JASTI has manufactured Hybrid III 95th LM based on **SAE Dummy Equipment Subcommittee Parts lists and drawings.**

The followed two points has been reported to JASTI from world wide customers. JASTI Hybrid-III95th LM has met completely with SAE standard.

1. Chest Jacket

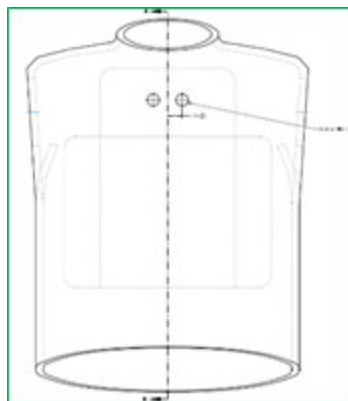
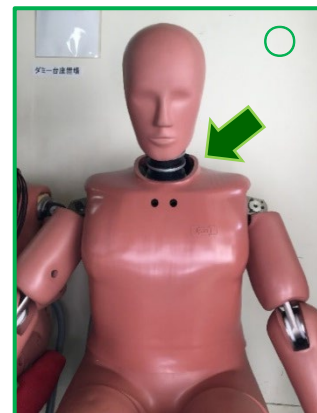
Neck are is different high and Chest Jacket shape is different.

NG : Neck area too high

SAE darwing Short

JASTImeet drawing

2. Pelvis and Femur assembly

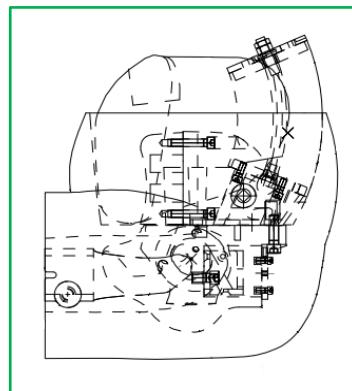
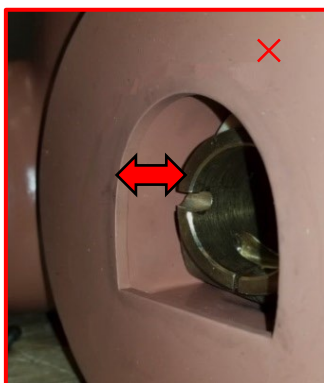
NG : Pelvic Femur Assembly inside Pelvis is too short as below picture.

Pelvis Assembly Drawing (Pelvis and Femur top at the same front position)

Femur front inside Drawing ; Same Front JASTI Pelvis & Femur
